ADDENDUM

Project Name:	Hamtramck Public Schools HVAC Upgrades Phase 2	Addendum No:	Two (2)
Project Number:	22-118	Issue Date:	September 21, 2022
Project Location:	Hamtramck, Michigan

To the Contract Documents for the requested: **HPS HVAC Upgrades Phase 2**

G:\2022\2022-0015-00\CAD\2022-0015-MD1-DP2.dwg, M1-03, 9/19/2022 1:57:56 PM, Joseph P. Giglio, Peter Basso Associates Inc.

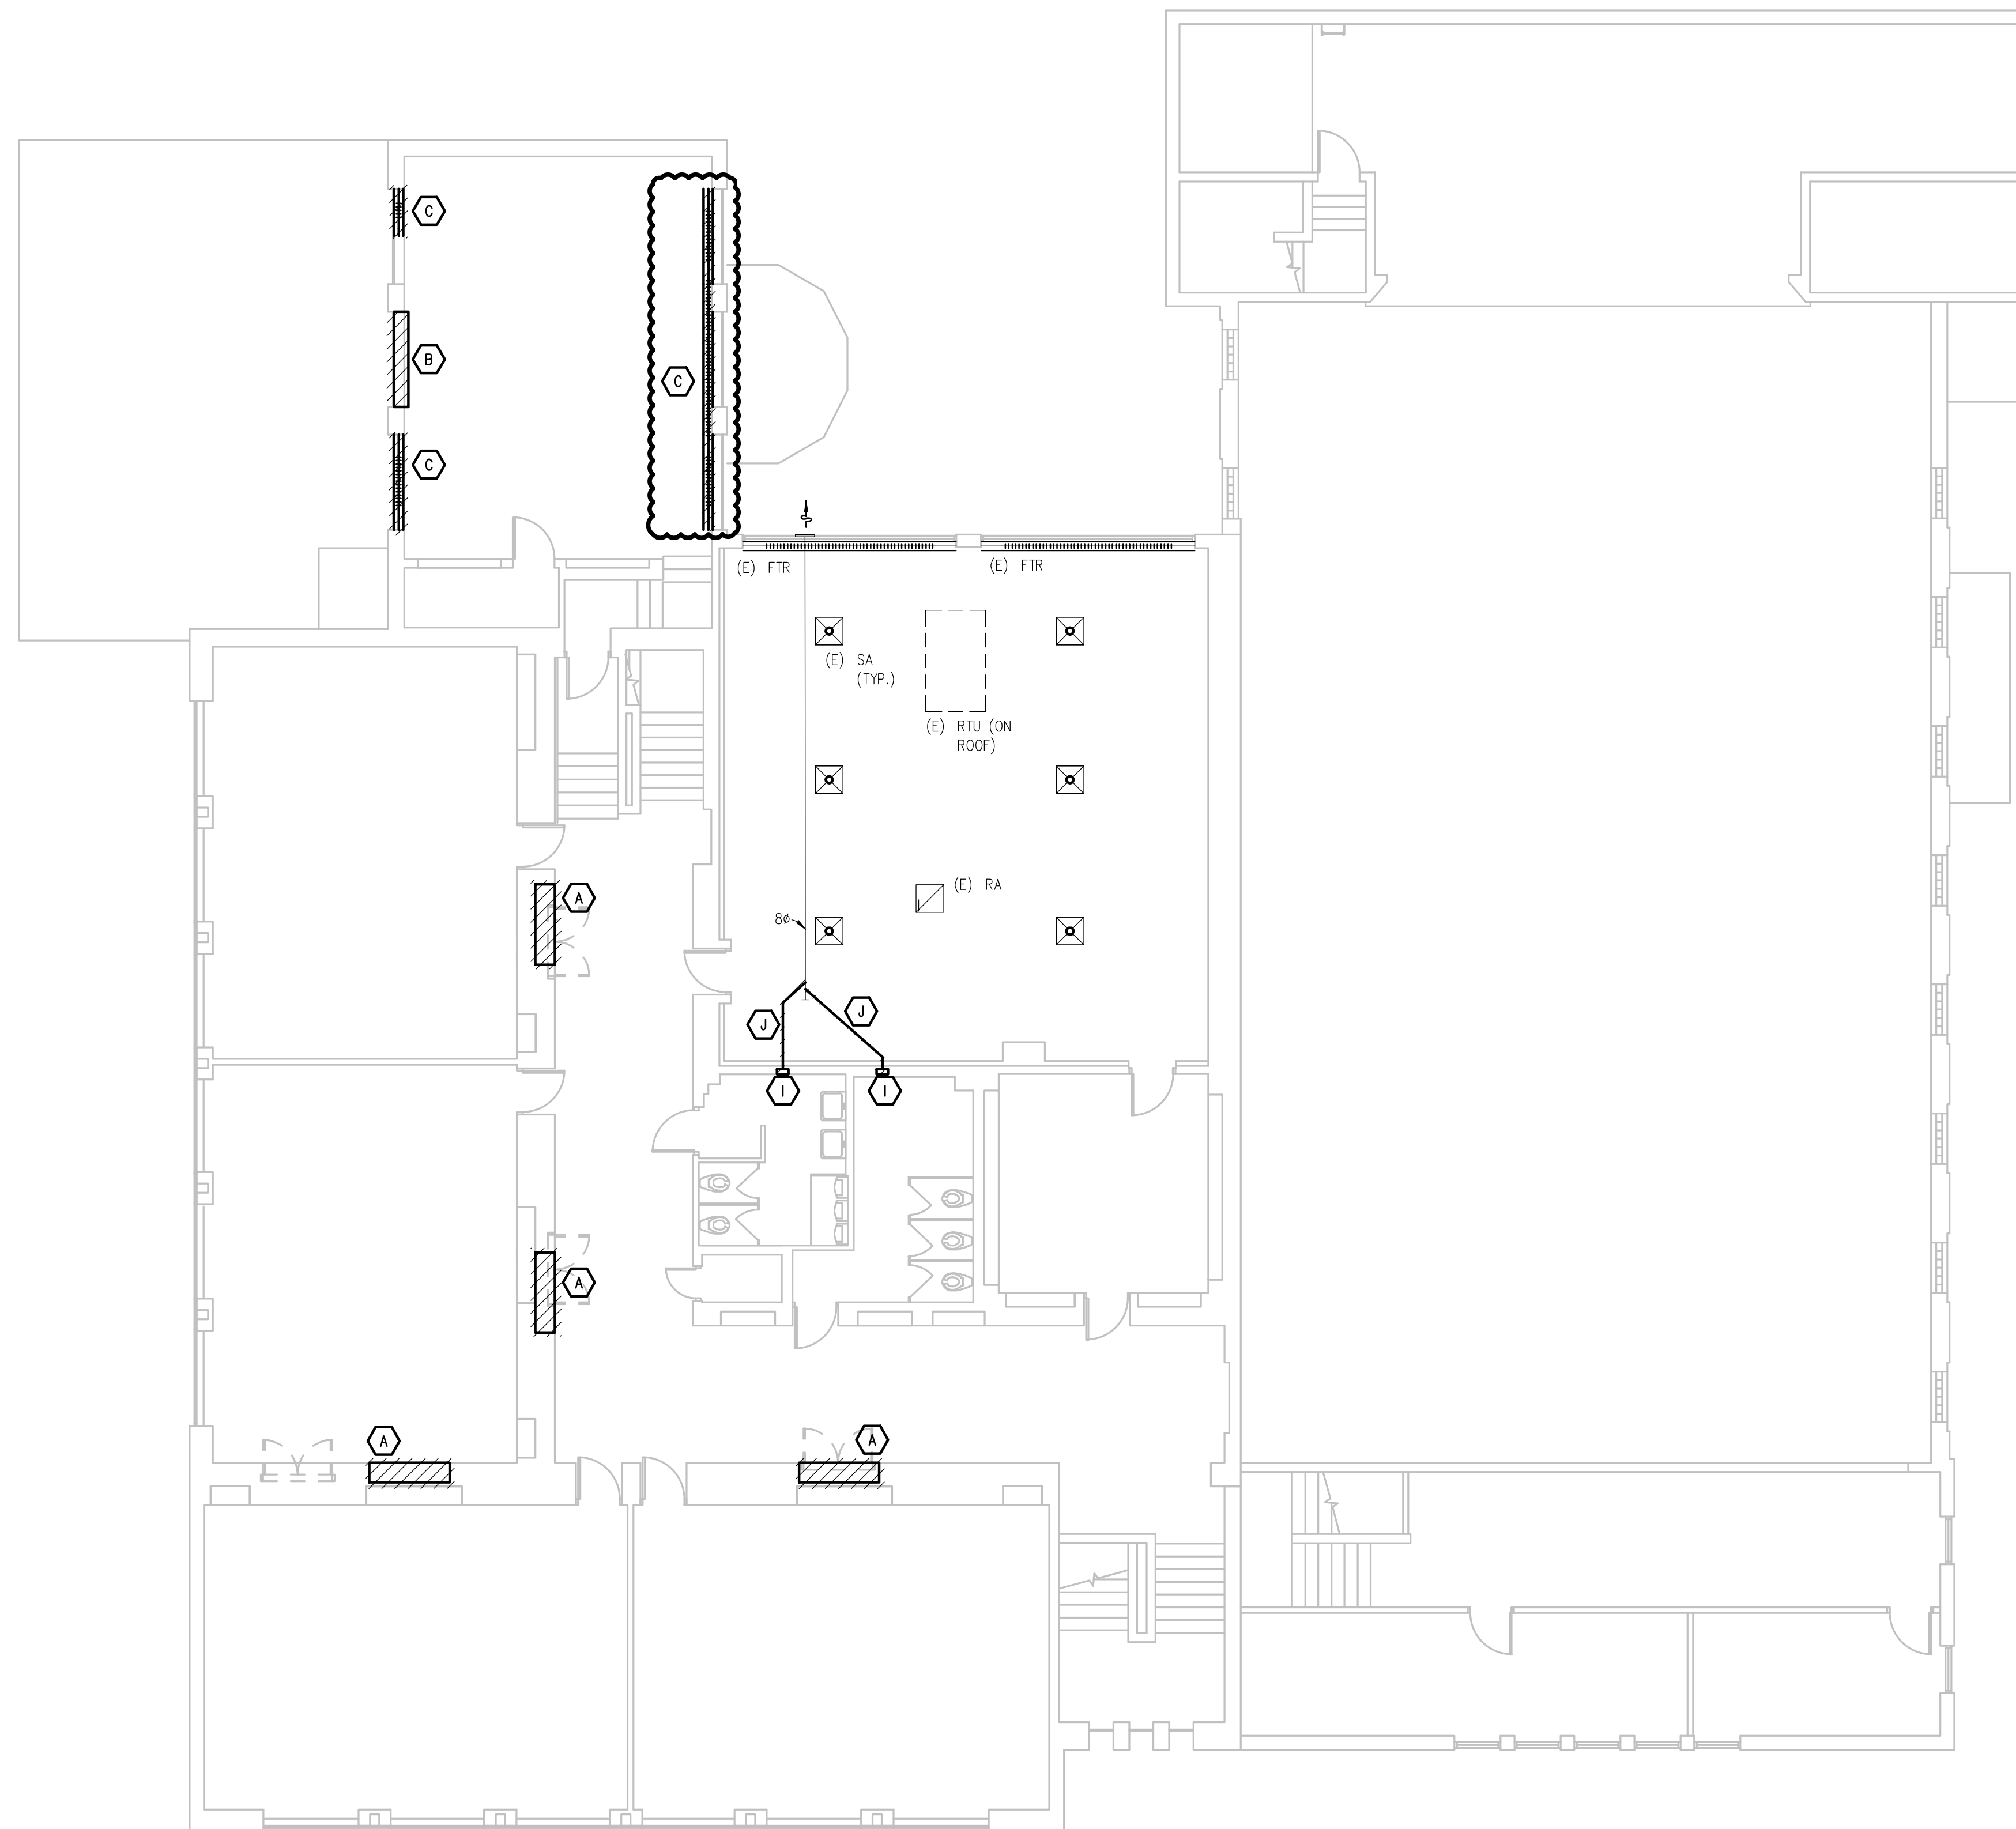
- Item M1** Drawing M1-01 LOWER LEVEL MECHANICAL DEMOLITION PLAN (revised but not re-issued):
A. Change Demo Key Note F to read: REMOVE INLINE EXHAUST FAN AND CAP VERTICAL DUCTWORK GOING UP (UPSTREAM). PREPARE DOWNSTREAM DUCTWORK (FROM TOILET ROOMS) FOR NEW CONNECTION.
- Item M2** Drawing M1-02 GROUND LEVEL MECHANICAL DEMOLITION PLAN (revised but not re-issued):
A. Change Demo Key Note K to read: REMOVE FTR AND CAP STEAM AND CONDENSATE PIPING IN A CONCEALED MANNER. CAP PIPING AS CLOSE TO MAIN AS POSSIBLE.
- Item M3** Drawing M1-03 UPPER LEVEL MECHANICAL DEMOLITION PLAN (re-issued):
A. Revise FTR piping demolition as shown.
- Item M4** Drawing M3-02 GROUND LEVEL HVAC PIPING PLAN (re-issued)
A. Revise refrigerant and condensate piping for AC-3 as shown.
B. Add Construction Note 14 as shown.

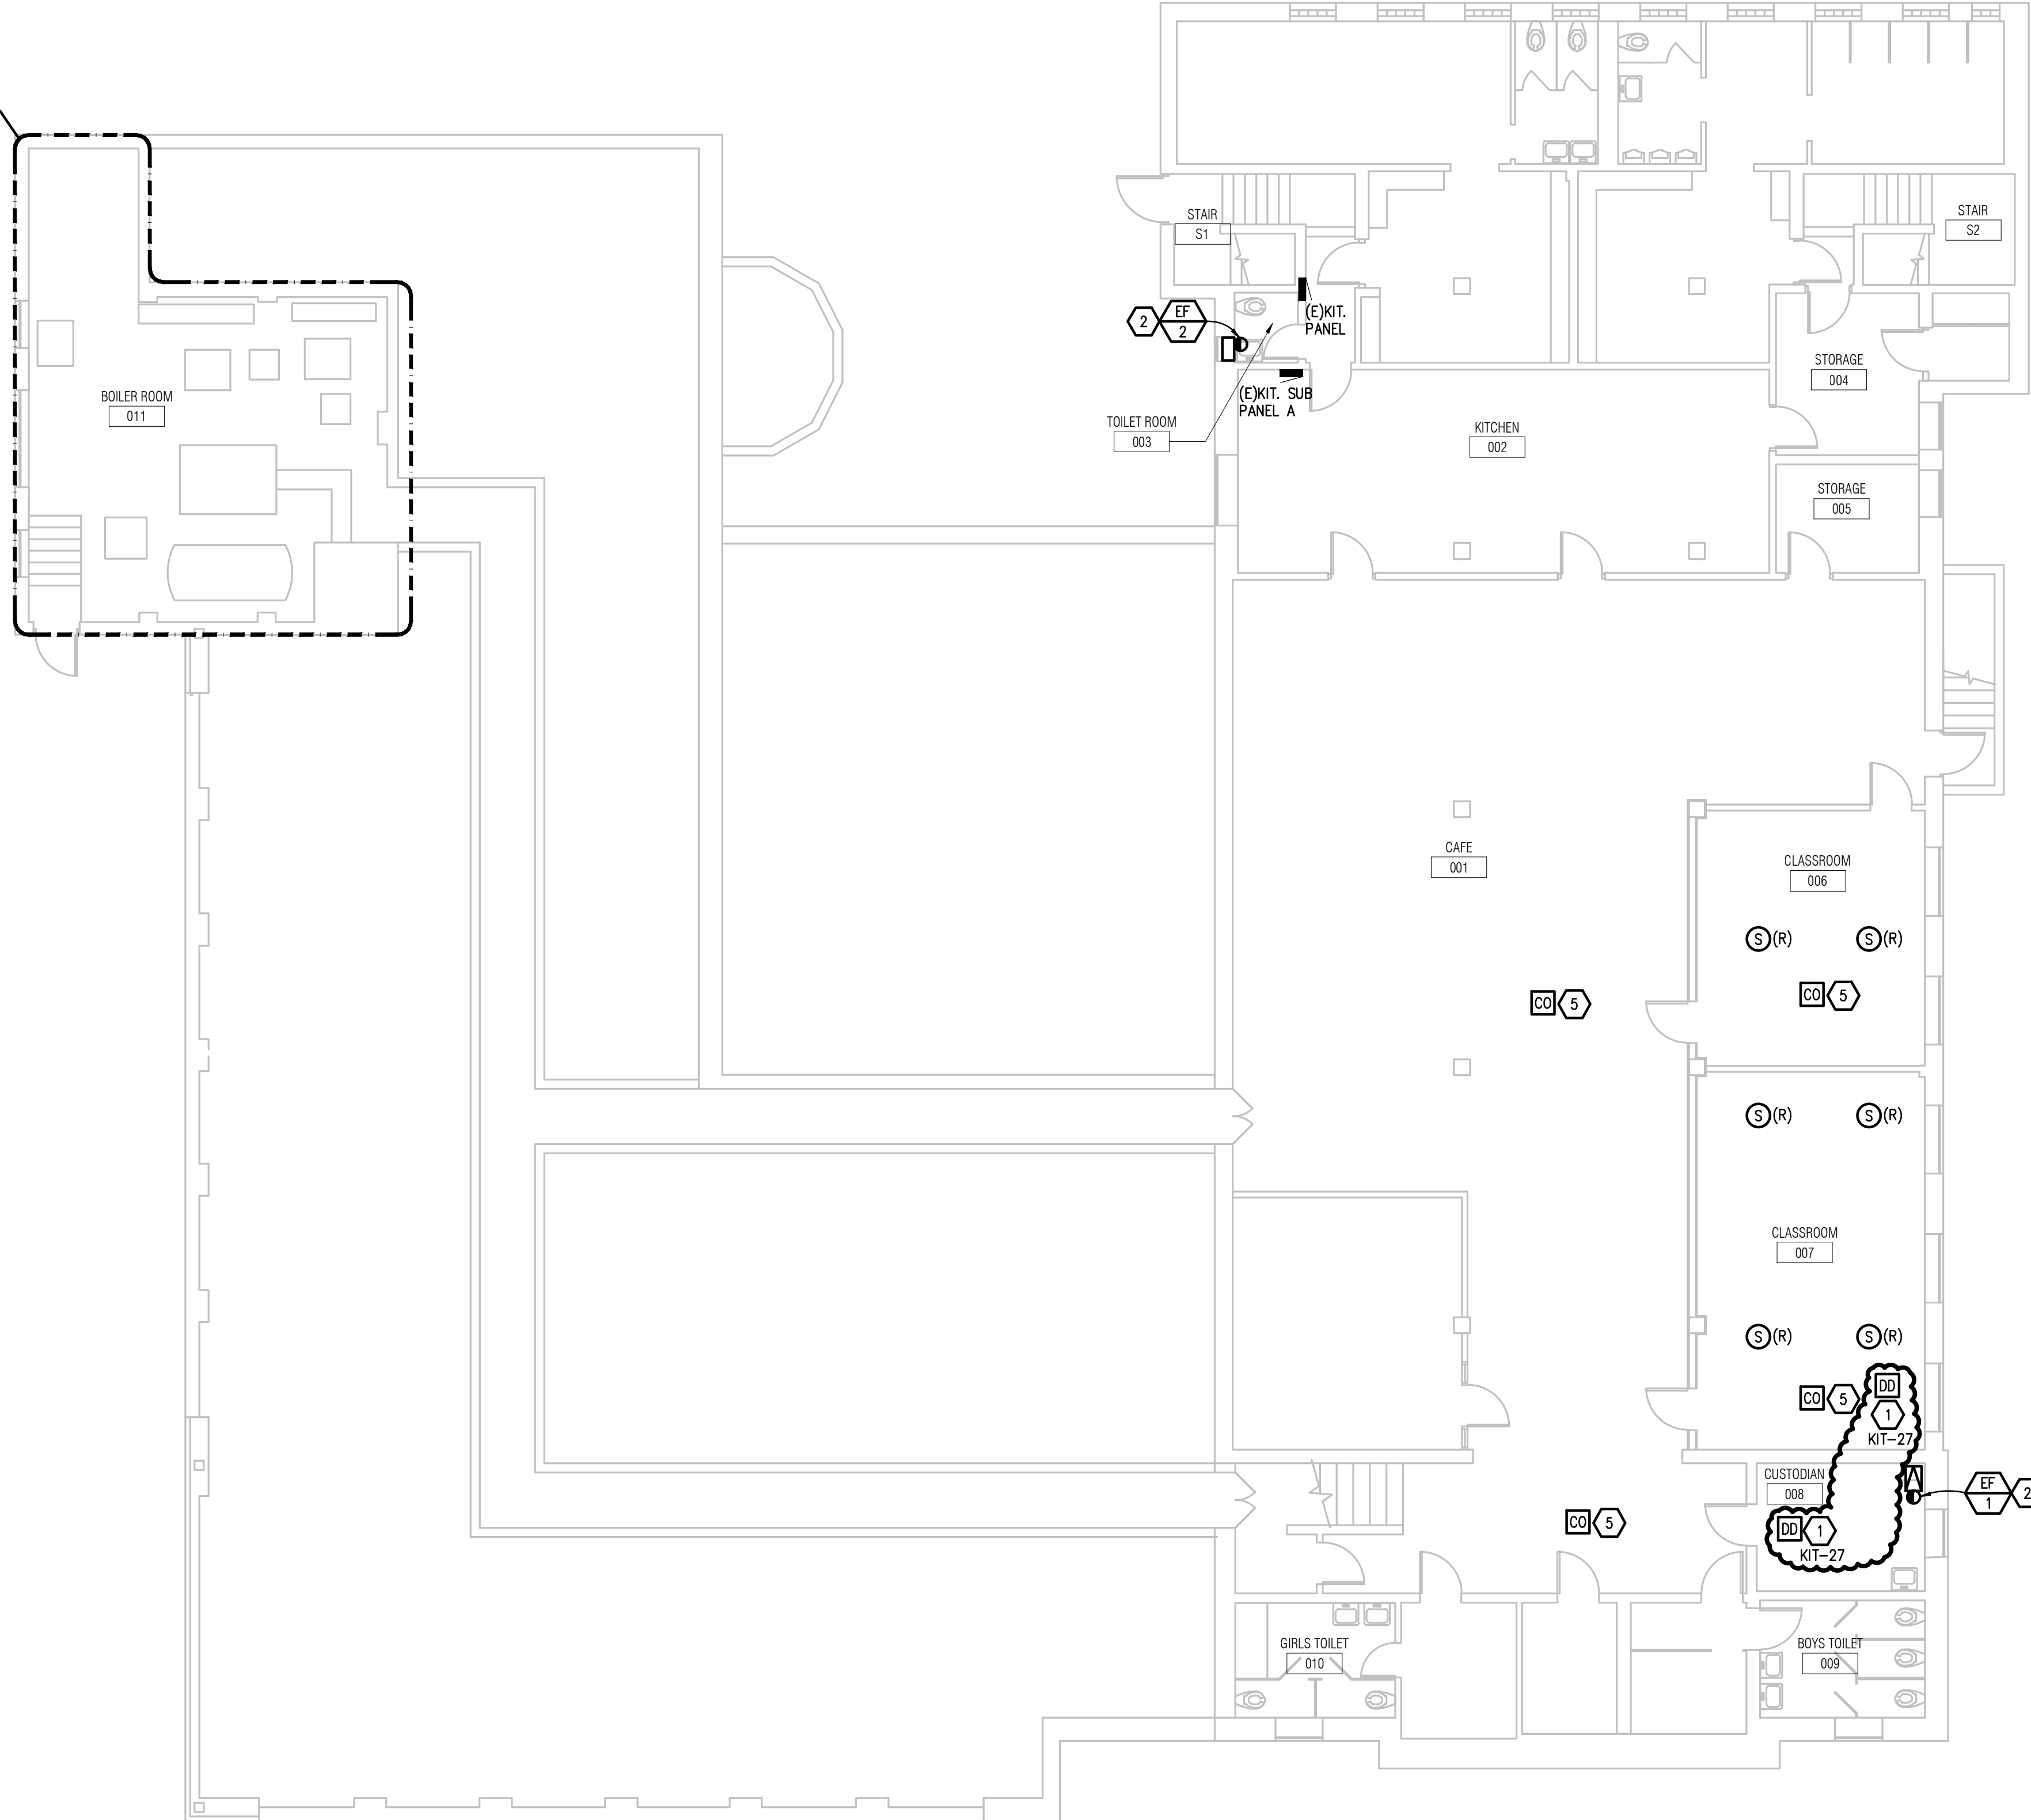
- Item E1** Drawing E3-01; LOWER LEVEL POWER PLAN (re-issued)
A. Revise location of duct detectors Classroom 007 and Custodian 008.
- Item E2** Drawing E3-02; GROUND LEVEL POWER PLAN (revised but not re-issued)
A. Remove all duct detectors in Office 124.
